July 8, 2010

Subject: IRM Work Plan Addendum
Former Service Station Site #E828143 – Town of Clarkson

FIGURE 1.
SAMPLE LOCATION PLAN
FMR. GAS STATION -- ENVIRONMENTAL RESTORATION PROGRAM
8264 RIDGE ROAD WEST
TOWN OF CLARKSON NEW YORK

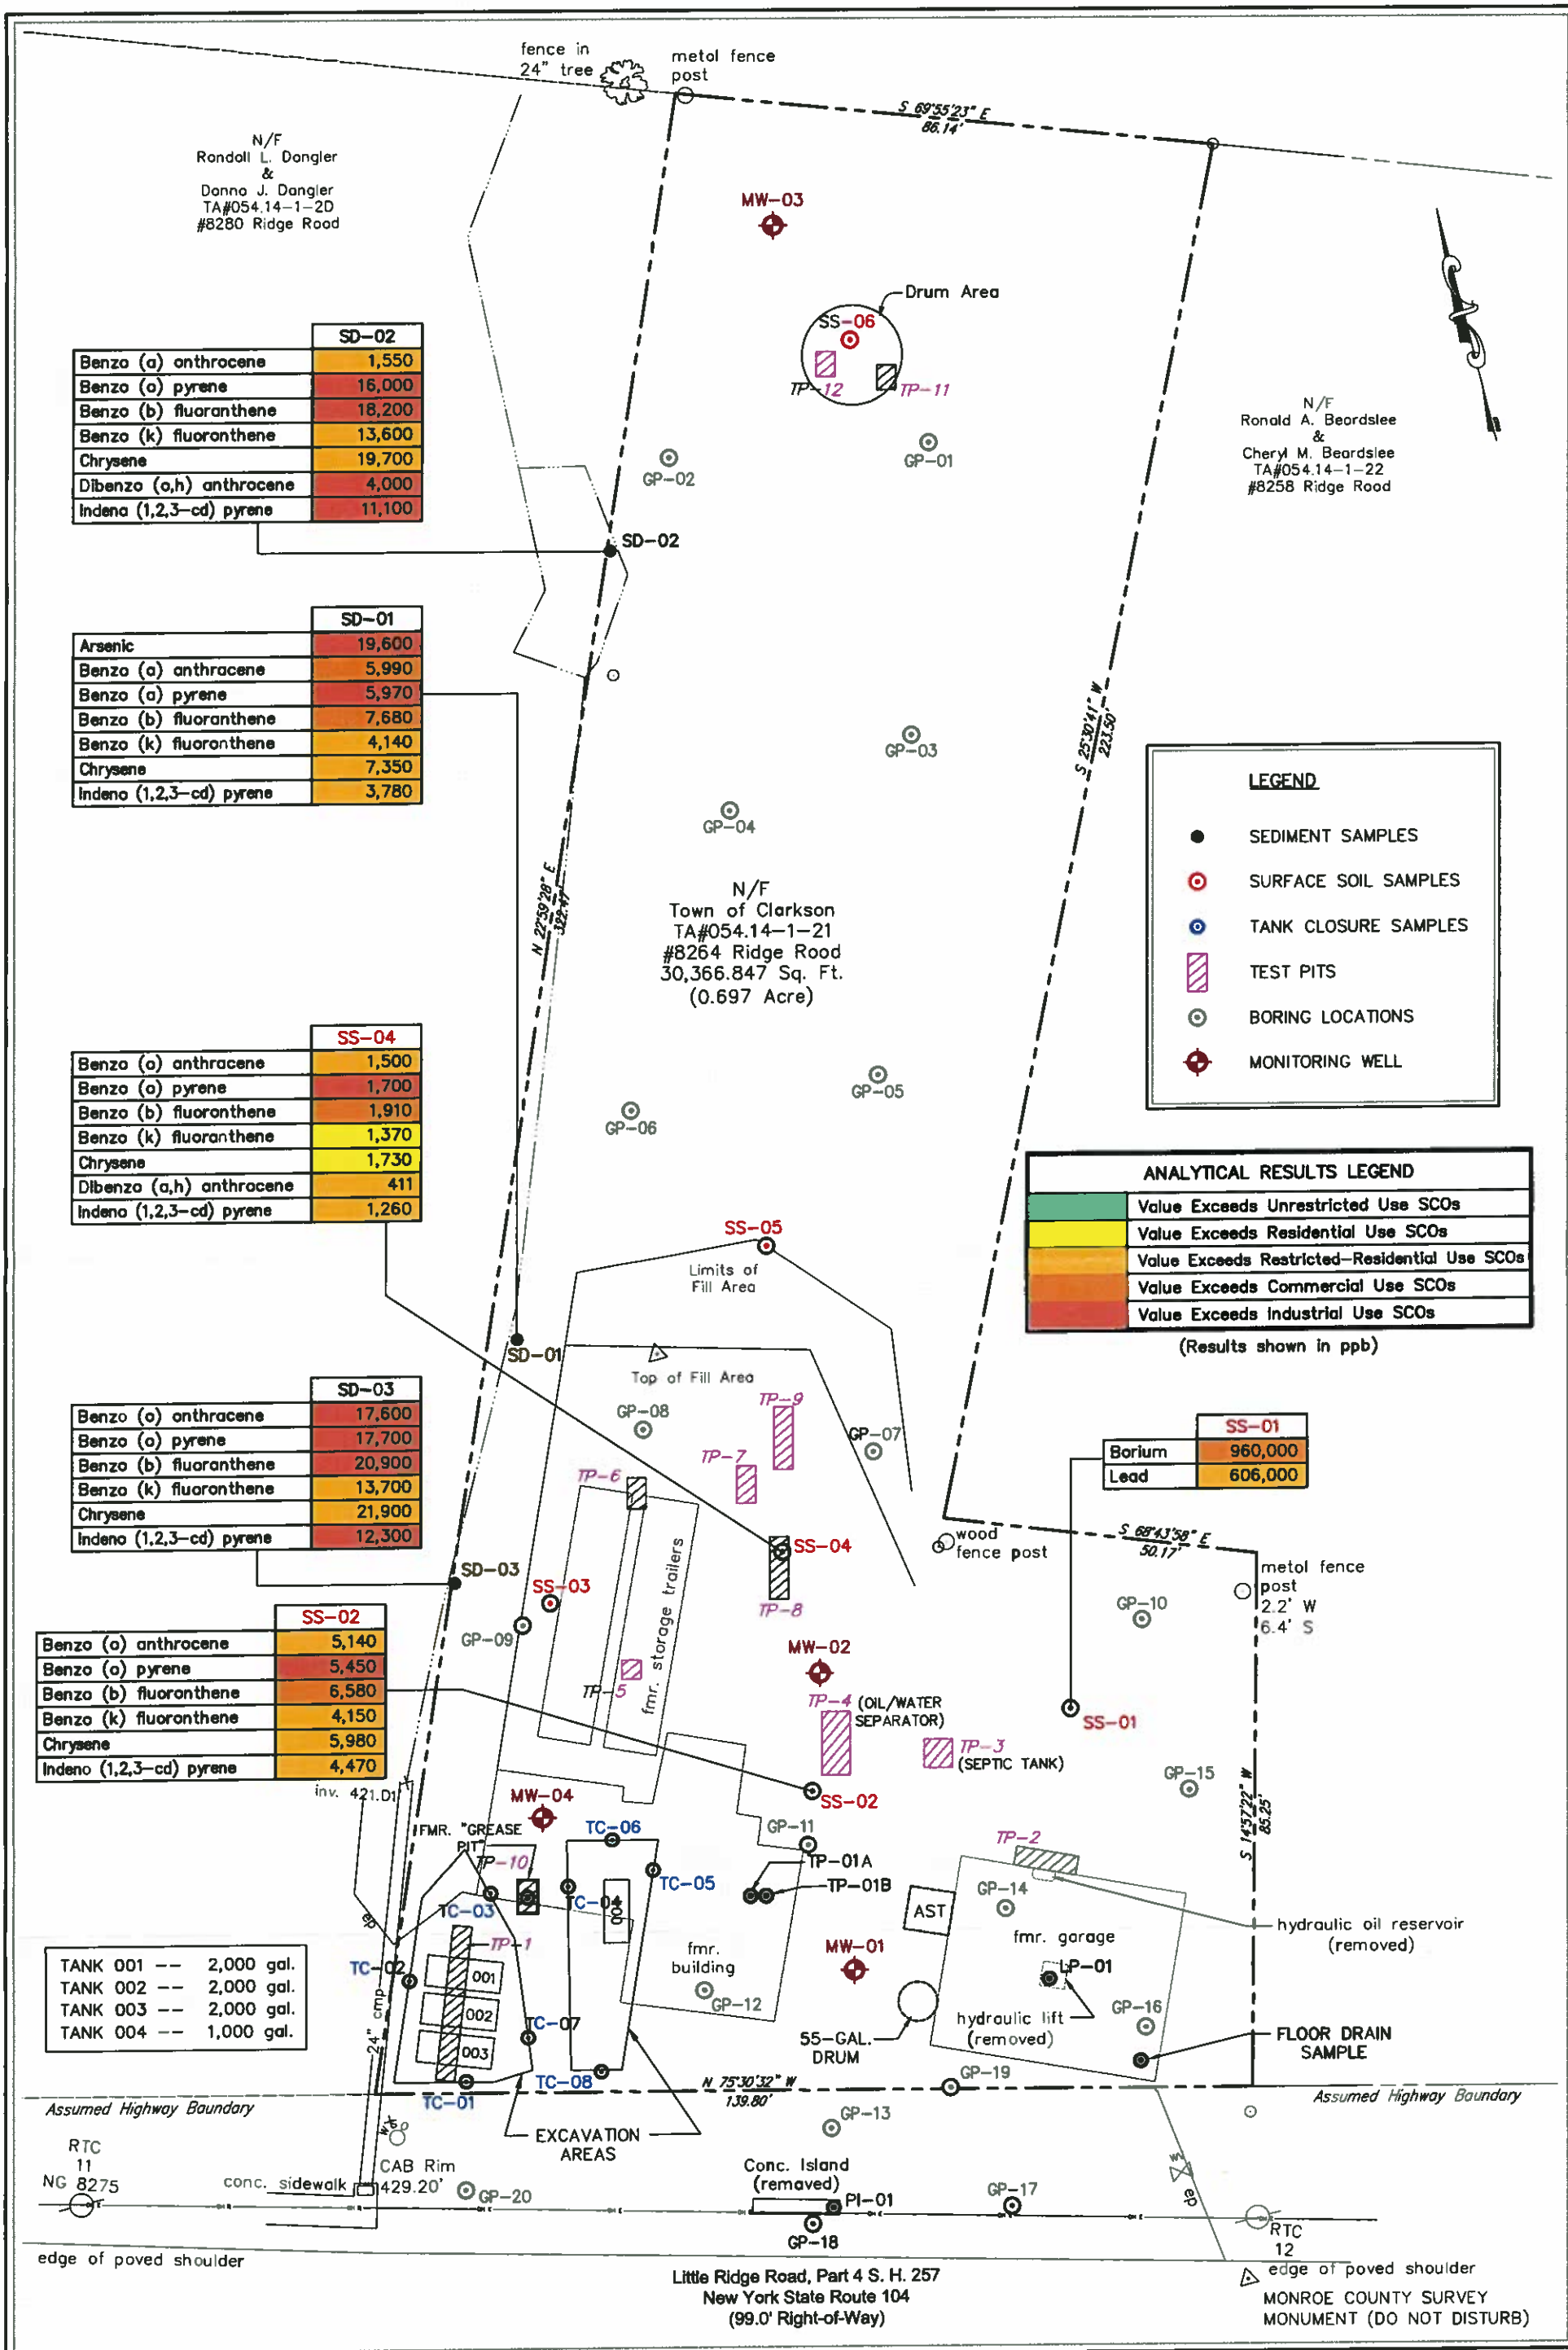
Additional IRMs are proposed to address elevated concentrations of SVOCs and metals in surface soils and drainage ditch sediments. Data obtained during the remedial investigation identified concentrations of polynuclear aromatic hydrocarbons (PAHs) above Industrial Use Soil Cleanup Objectives (SCOs) in surface soils at locations SS-02 and SS-04. Barium was also detected above the Commercial Use SCO at surface soil sample location SS-01. Sample locations and results are shown on the attached Figure 1.

Sediment samples collected from the drainage ditch along the western property boundary indicated PAH concentrations above Industrial Use SCOs at each sampling location (SD-01, SD-02, and SD-03). Arsenic was detected above the Industrial Use SCO at location SD-01, as indicated on Figure 1.
